Title - Sujet Highway Resurfacing and Other Work	
Solicitation No. - N° de l'invitation EZ899-151714/A	Amendment No. - N° modif. 003
Client Reference No. - N° de référence du client	Date 2015-02-13
GETS Reference No. - N° de référence de SEAG PW-\$PWY-015-7426	
File No. - N° de dossier PWY-4-37255 (015)	CCC No./N° CCC - FMS No./N° VME
Solicitation Closes - L'invitation prend fin at - à 02:00 PM on - le 2015-02-25	Time Zone Fuseau horaire Pacific Standard Time PST
F.O.B. - F.A.B. Plant-Usine: <input type="checkbox"/> Destination: <input checked="" type="checkbox"/> Other-Autre: <input type="checkbox"/>	
Address Enquiries to: - Adresser toutes questions à: Chan (PWY), Scarlett	Buyer Id - Id de l'acheteur pwy015
Telephone No. - N° de téléphone (604) 775-9382 ()	FAX No. - N° de FAX (604) 775-6633
Destination - of Goods, Services, and Construction: Destination - des biens, services et construction: Parks Canada - Pacific Rim National Park - Tofino, BC

Public Works &
Government Services Canada
Highway Resurfacing & Other Work, Hwy #4,
Km. 0.000 to km. 21.500
Through Pacific Rim National Park
Project No. R.067785.001

ADDENDUM No. 3

Highway 4 Resurfacing Project - Culvert Location Map

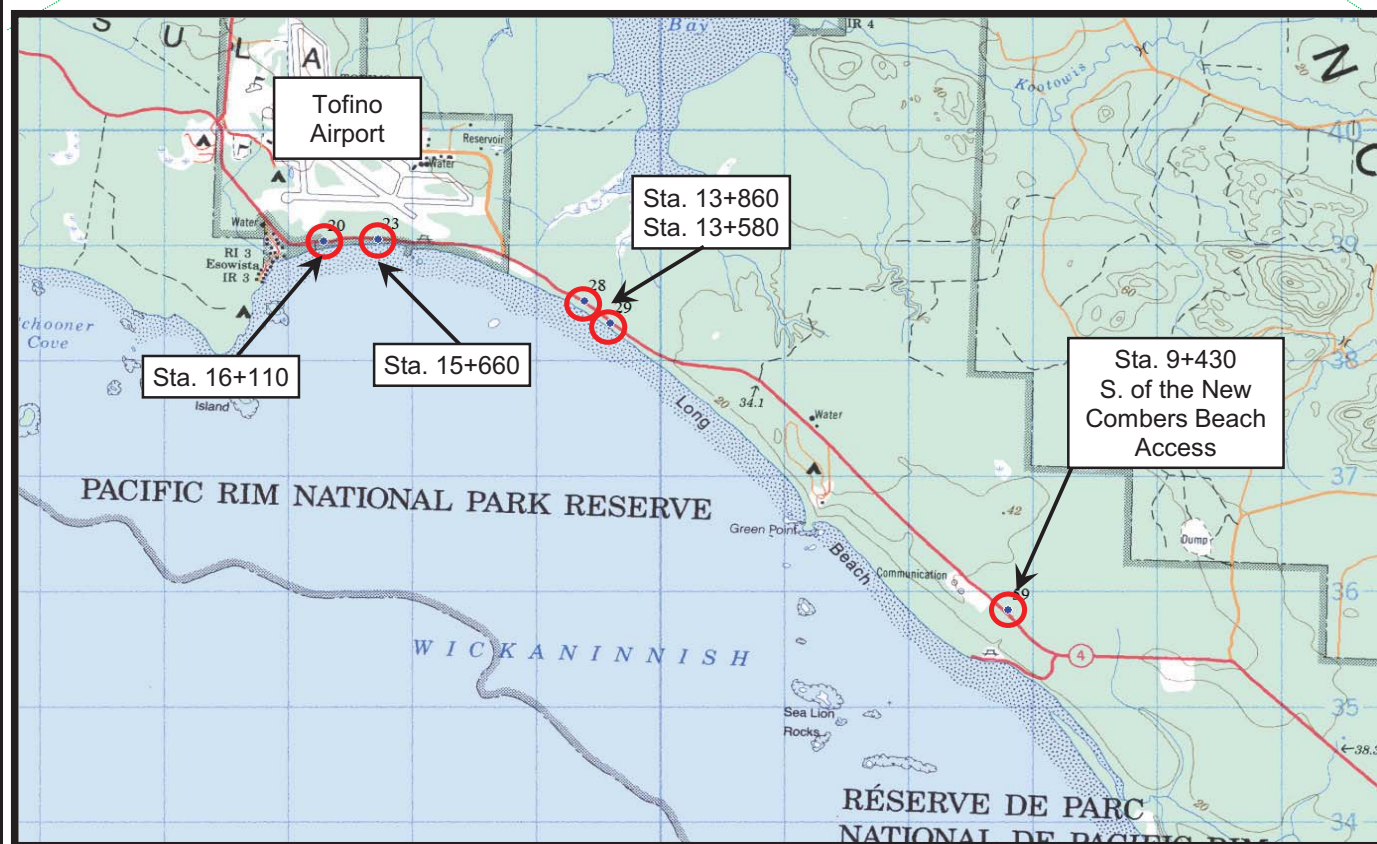
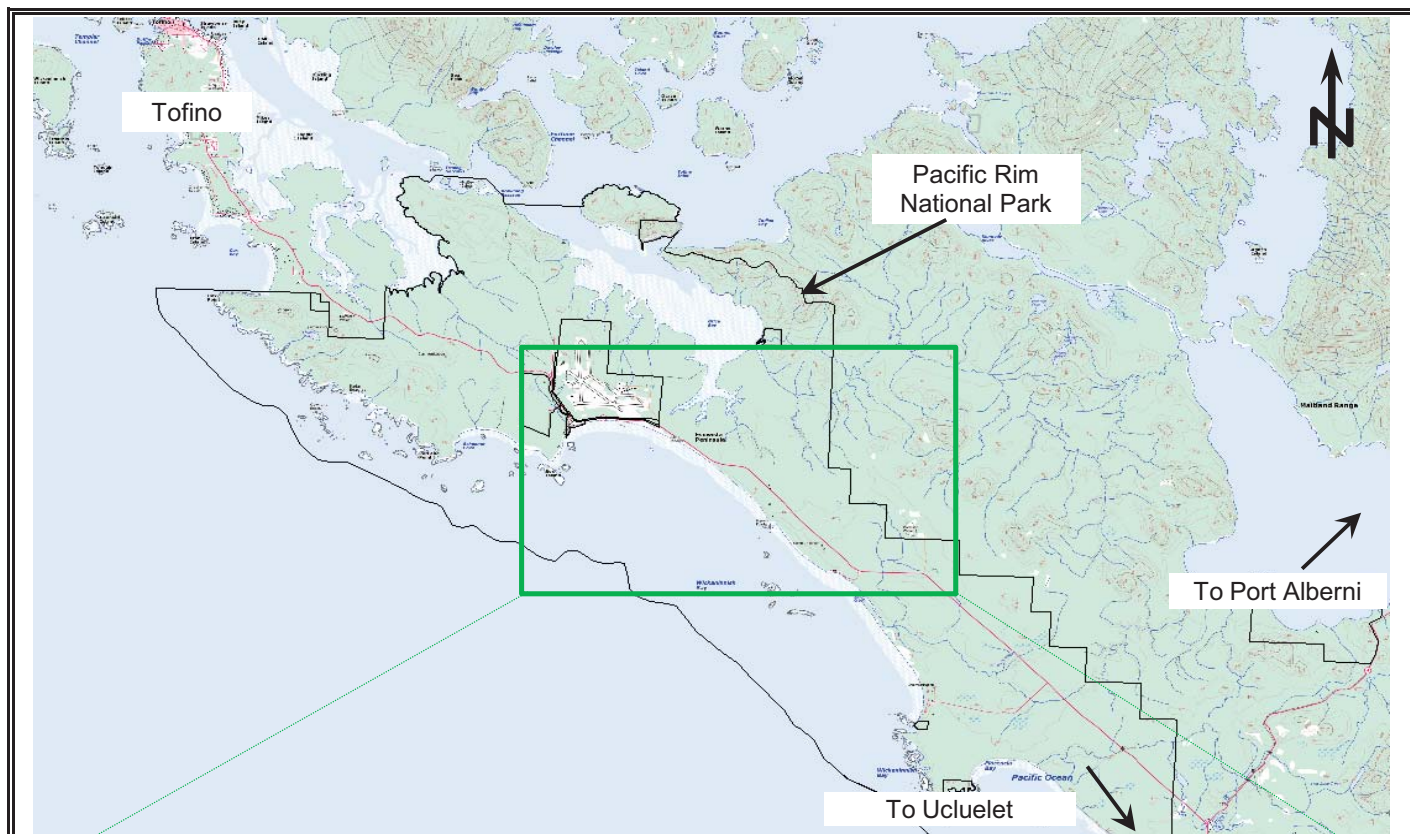
- Q1. At Station 13+580, 13+860 & 16+110 it is hard to determine the exact location of the pipes to be replaced. Can the culvert be marked with a survey stake and ribbon?
- A1. The five culverts included in the tender have been marked on site with a stake flagged with blue and pink ribbon. Each stake is located over the culvert adjacent to the northbound lane. The culvert locations can further be located using the coordinates listed below, and the attached map.

Station (km)	Latitude	Longitude
16+110	49.07282	-125.777
15+660	49.07309	-125.771
13+860	49.06882	-125.748
13+580	49.06719	-125.745
9+430	49.04587	-125.700
